## **Interconnection Facilities Study Report GI-2007-4**

**300 MW Wind Generation Expansion (600 MW Total)  
Interconnecting at Ault Substation**

**PSCo Transmission Planning  
January 6, 2011**

## **Customer Questions and Comments**

**Figure 1: Diagram of the GI-2007-4 Interconnection at Ault 230 kV**

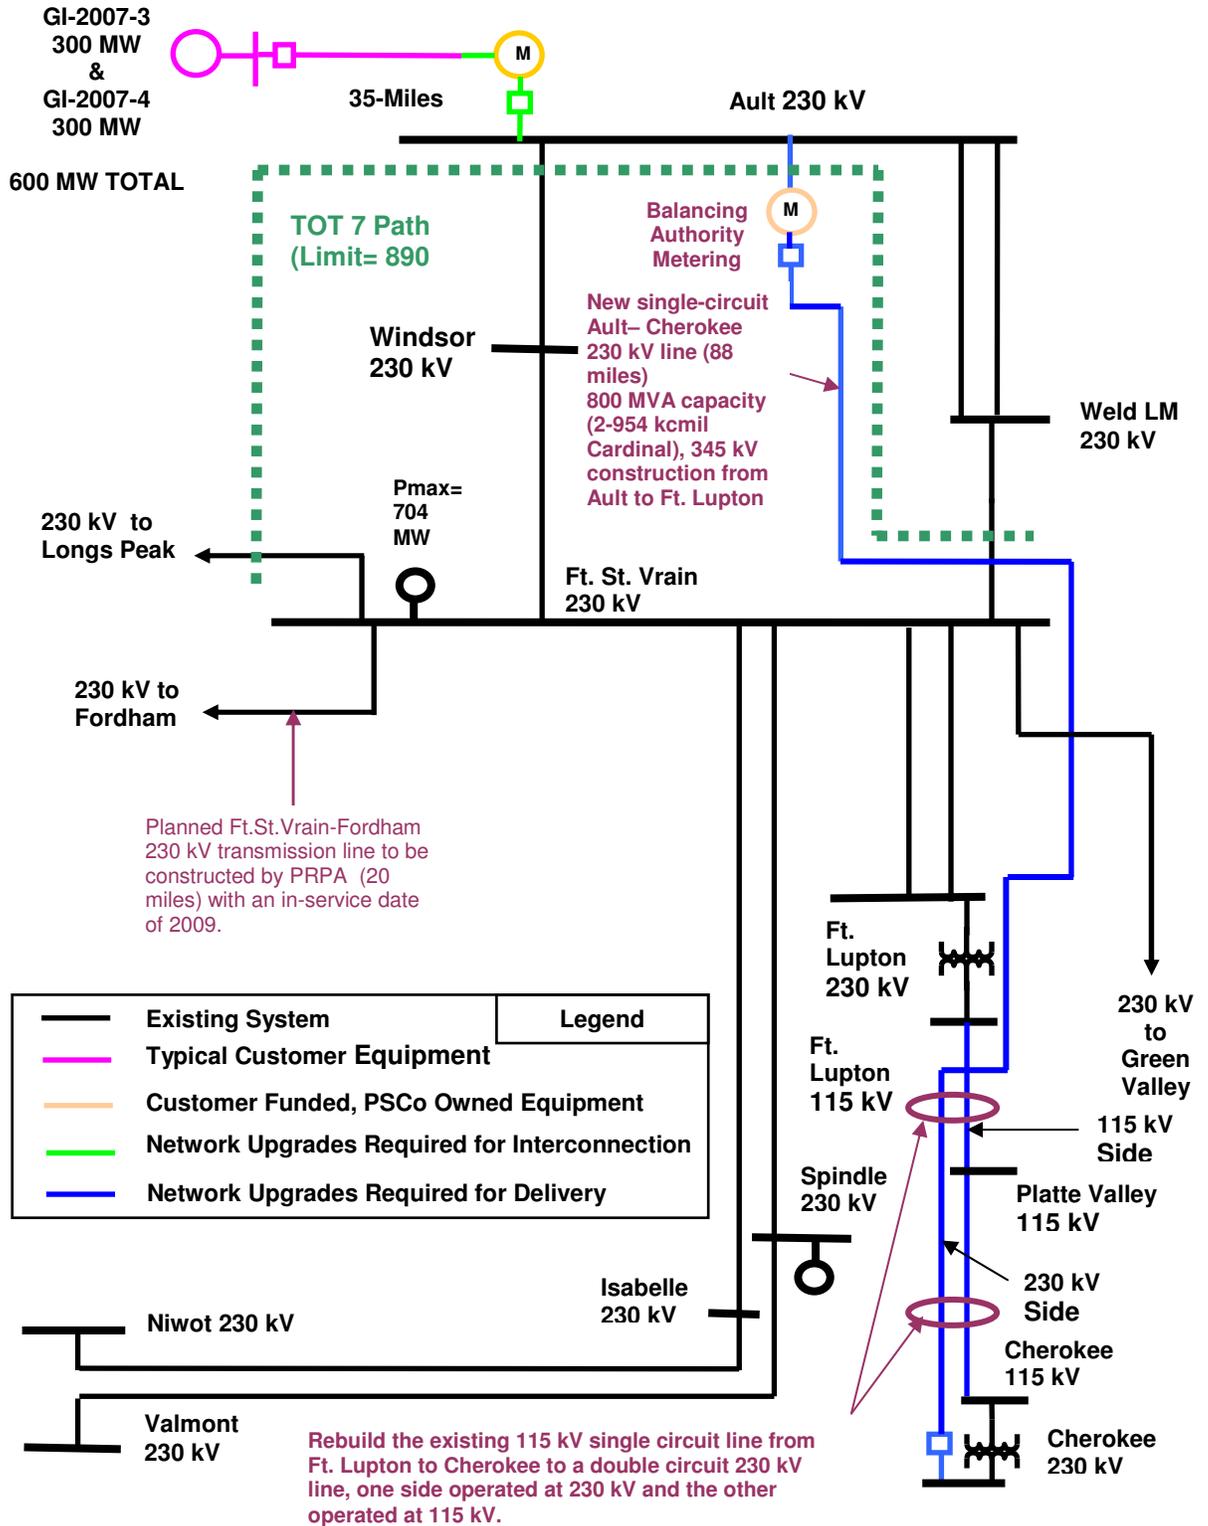
1. Why is 345 kV construction specified on the proposed Ault – Cherokee 230 kV?, Is it necessary?
  - a. 345kV construction is specified in Figure 1 to be consistent with the outlined Ault – Cherokee project scope that was submitted under the Senate Bill – 07 – 100 filing. This scope will be further clarified in the CPCN filing with the Colorado PUC. In order for the Customer to interconnect at the Ault substation, the Ault – Cherokee 230 kV line will still be a necessary Network Upgrade, and the tower construction should have no direct impact on the Ault – Cherokee 230kV line itself. The customer will not be paying for the Ault – Cherokee 230 kV line if PSCo completes the line as a SB – 07 – 100 project.
